This supporting document is submitted on behalf of Berekdar Developments Limited in support of a section 73 application for the development of the residential site located at 37 Edward's Avenue in Ruislip.

The scope of the document is to provide details of the proposals to improve the previously approved scheme under Full Planning Application with the reference number 65680/APP/2011/36 and planning condition discharge with the reference number 65680/APP/2014/2485.

2.1 PROPOSAL COMPARISON - PLANS

Proposed northeast elevation plan (not to scale)

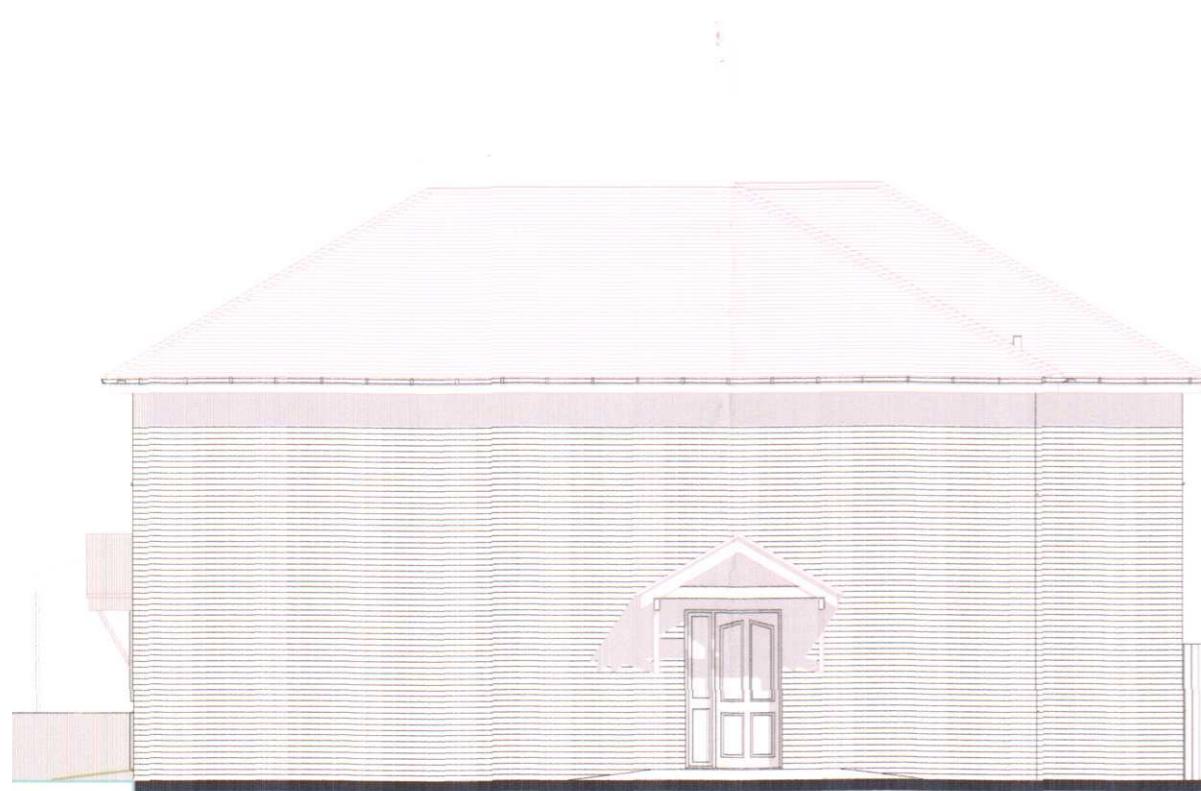
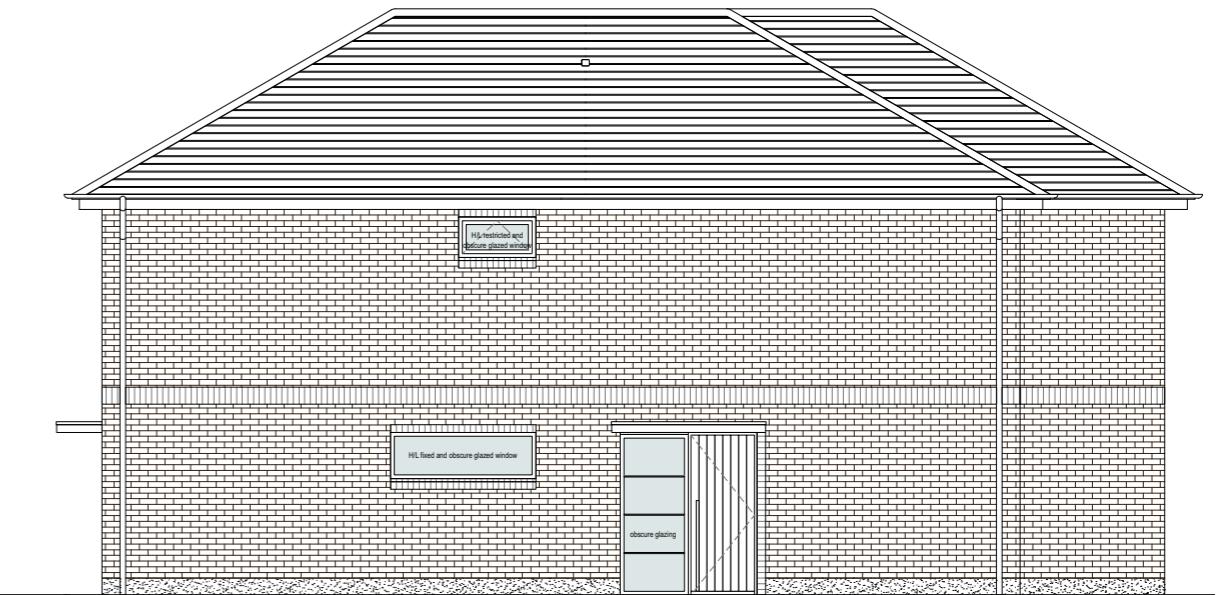
- Building and openings set out to metric brick sizes
- Entrance doors and glass side panels revised
- External building design modernised, whilst referencing it to 1940s/50s dwellings of similar nature found in the close vicinity of the site (see precedent image 1 for

- Brick detailing such as soldier courses and window cills in brick proposed
- Level thresholds provided to access the building
- Pitched roof canopies replaced with flat roof canopies
- Rear facade bifold doors provided to living rooms

- Window design amended, providing energy-efficient aluminium framed glazing in dark grey, with muntins to imitate heritage window
- Rendered plinth introduced
- Dark red/brown concrete roof tiling proposed

- High-level obscure glazed, restricted or fixed shut windows to site elevation proposed
- Roof form corrected as it was drawn incorrectly on the approved plans.
- Roof pitch has been retained.
